RENESAS TECHNICAL UPDATE

Product Category	MPU MCU		Document No.	TN-SH7-A761A/E	Rev.	1.00
Title	Correction of errors in SH7216 Group Manual	Hardware	Information Category	Technical Notification		
Applicable Product		Lot No.				
	SH7216 Group SH7214 Group	after 0948(EIA code)	Reference Document	SH7216 Group Hardw Rev. 1.01 (REJ09B054		ıal

We would like to inform you that errors have been found in the hardware manuals of applicable products mentioned above. For details, see below.

Figure 27.2 Block Diagram of ROM

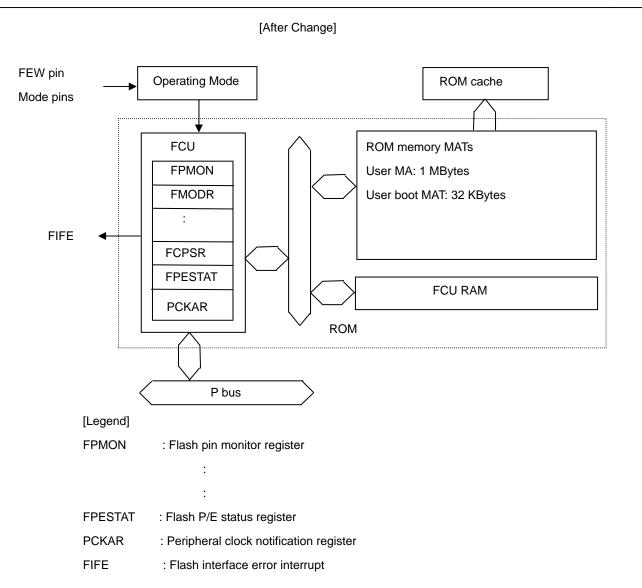
"Figure 27.2, Block Diagram of ROM" on page 1439 in section 27, Flash Memory (ROM), was amended as follows.

FPESTAT : Flash P/E status register

FIFE : Flash interface error interrupt

Figure 27.16 Overview of the Flow of Processing for Programming and Erasure

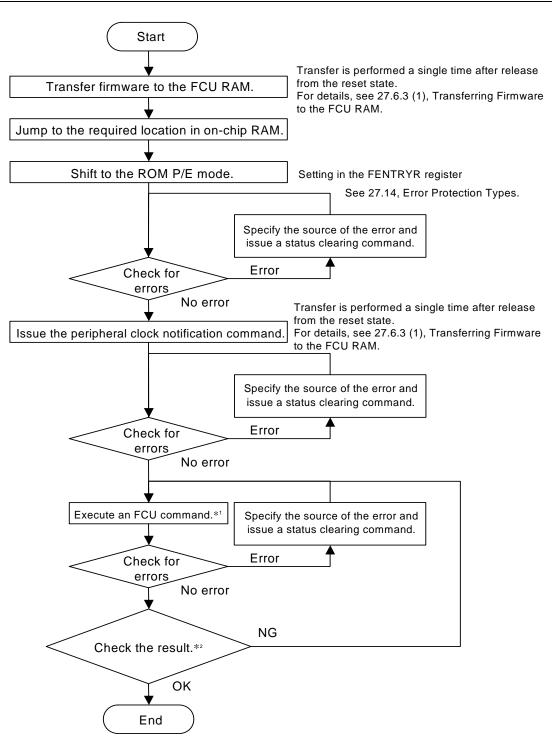
The description under "section 27.6.3, FCU Command Usage" on page 1512 in section 27, Flash Memory (ROM), was amended as follows.

Figure 27.16 gives an overview of the flow of processing for programming and erasure.

Notes: 1. This is a program, block erase, lock-bit program, or lock-bit read 2 command.

To confirm the result of programming or erasure, place the ROM in ROM-read mode and then read the data. For details, see 27.6.3(4), Transition to ROM-read mode.

Figure 27.18 Flow for Using the Peripheral Clock Notification Command

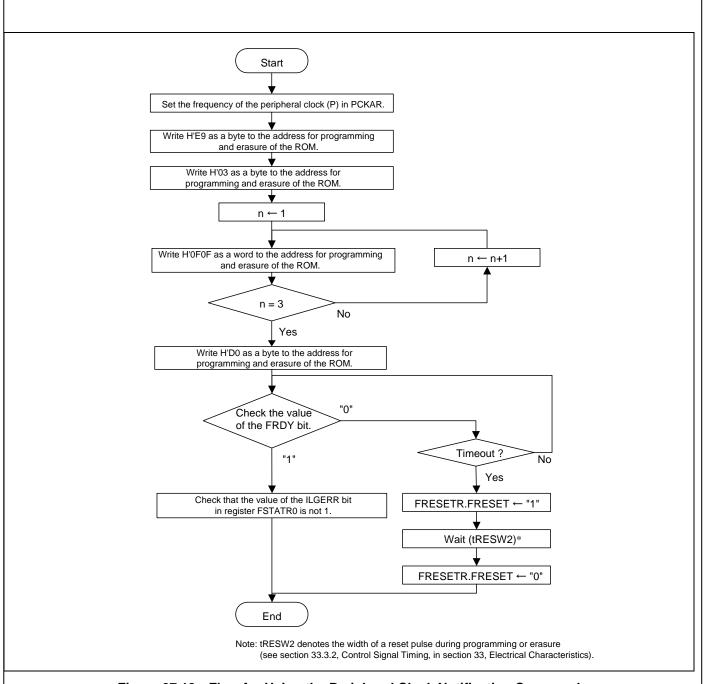
The following description was added as "(4) Using the peripheral clock notification command" on page 1514 in section 27, Flash Memory (ROM).

The frequency of the peripheral clock to be used for programming or erasure of the flash memory (ROM) must be set in the PCKAR. Selectable values are in the range from 20 to 50 MHz. If the setting is not in this range, the FCU detects an error and enters the command-locked state (see section 27.9.3, Error Protection).

The peripheral clock notification command is used after setting the PCKAR register. For a peripheral clock notification command, H'E9 and H'03 are written in byte units in the first and second cycles, respectively, to the address for programming or erasure of the ROM. In the third to fifth cycles of the command, writing is executed in word units. As the first address, use an address that is aligned with a four-byte boundary. After H'0F0F has been written as a word unit three times to the address for programming or erasure of the ROM, when H'D0 is written as a byte unit to the address for programming or erasure of the ROM, the FCU starts processing for setting the frequency of the peripheral clock. Completion of the setting can be confirmed by checking the value of the FRDY bit in the FSTATR0 register.

After release from the reset state, if the peripheral clock settings in use are not changed, execution once makes the setting valid for subsequent FCU commands.

Figure 28.2 Block Diagram of FLD

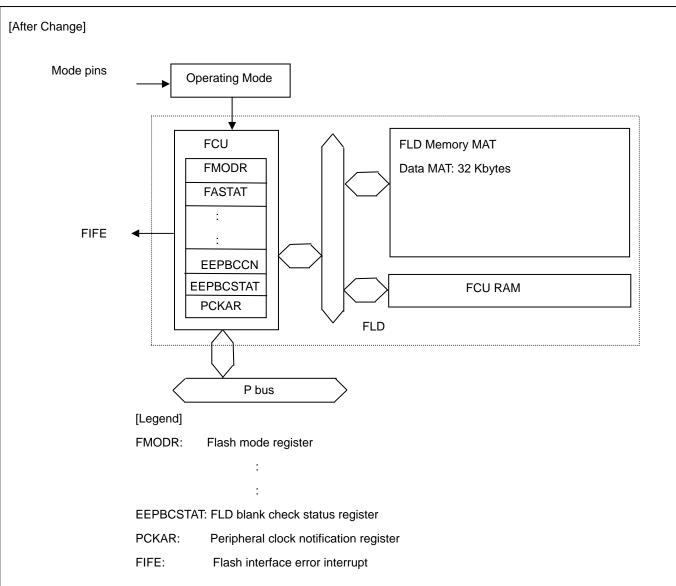
RENESAS TECHNICAL UPDATE TN-SH7-A761A/E "Figure 28.2, Block Diagram of FLD" on page 1547, in section 28, Data Flash (FLD), was amended as follows. [Before Change] Mode pins **Operating Mode** FLD MATs FCU FMODR Data MAT: 32 KBytes **FASTAT FIFE EEPBCCNT** FCU RAM **EEPBCSTAT** FLD P bus [Legend] FMODR: Flash mode register EEPBCSTAT: FLD blank check status register FIFE: Flash interface error interrupt
